ENVIRONMENTAL REVIEW TEAM REPORT

BEAVER BROOK FLOOD CONTROL PROJECT MILFORD, CT

**BEAVER BROOK FLOOD
CONTROL PROJECT
MILFORD, CT
SEPTEMBER 1984**

FIGURE 6 SOILS MAP

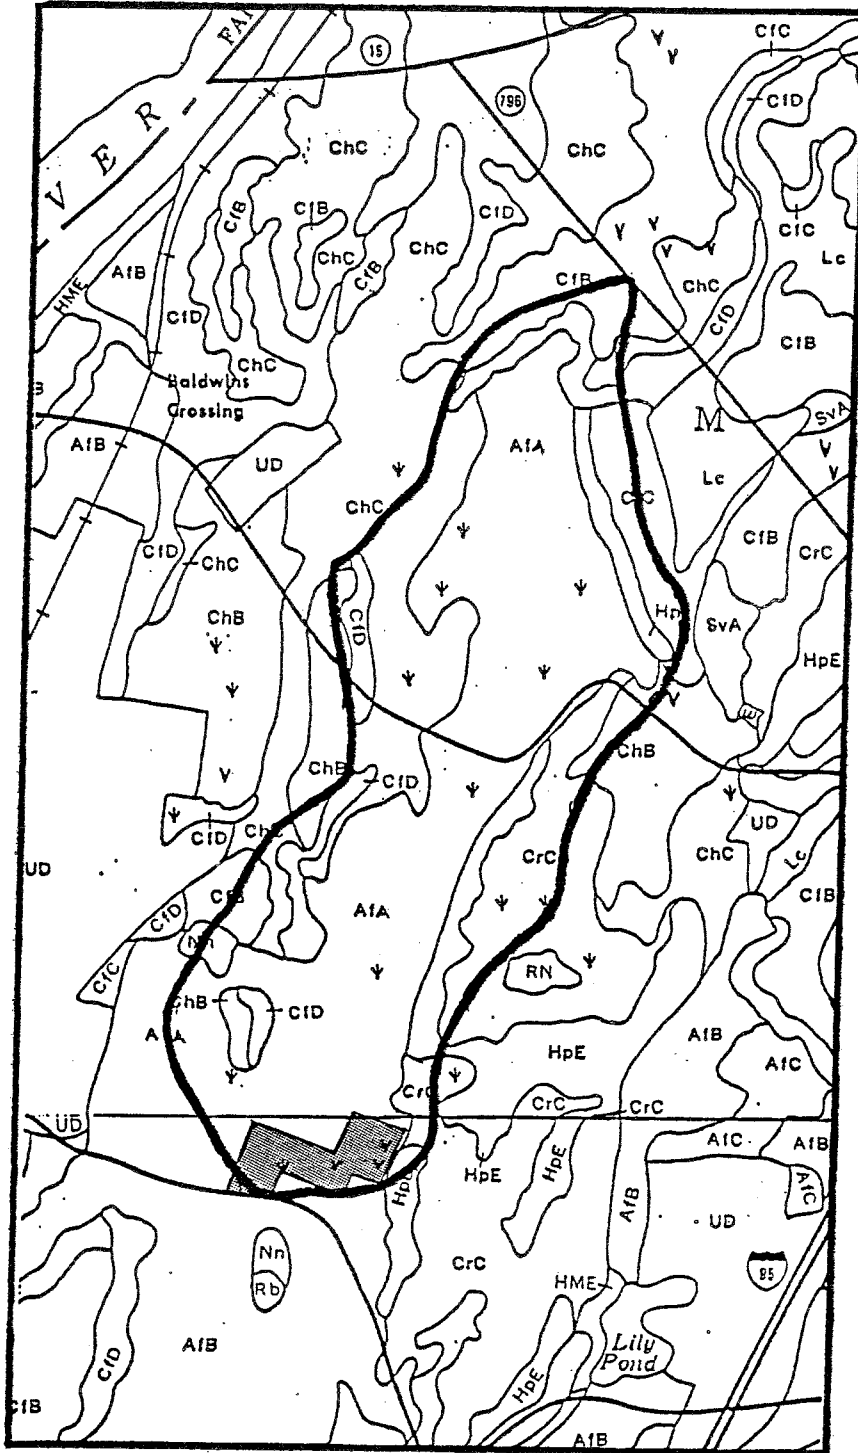
Bedrock exposures within the study area are visible mainly in the areas delineated as HpE (Hollis-Charlton) on the accompanying soils map (see Figure 6). Rock outcrops were observed on the review day north of the flood-prone area and along West Rutland Road in the eastern limits of the study area.

There are some shallow depressions in this area mapped AfA that collect water after heavy rains and during periods of snowmelt. These depressions have soils that are moderately well to poorly drained. These wet spots are identified with the symbol "Ψ" on Figure 6.

There are exposures of rock outcrop on the east side of the property adjacent to West Rutland Road. These areas of rock are identified with the symbol "V" on Figure 6.

The fast permeability of the sand and gravel make the Agawam soils well-suited for detention basins. The water collected in a basin can be metered out downstream as well as added to the groundwater table by infiltration and percolation through the pond bottom. Some spots mapped as Agawam on the water company property are moderately well to poorly drained. These areas will add water to the detention basin, however the amount of water should be relatively small and not greatly affect the performance of the basin.

The Agawam soil has poor suitability for embankments due to seepage. More suitable material may have to be brought in to construct a dike around the basin.
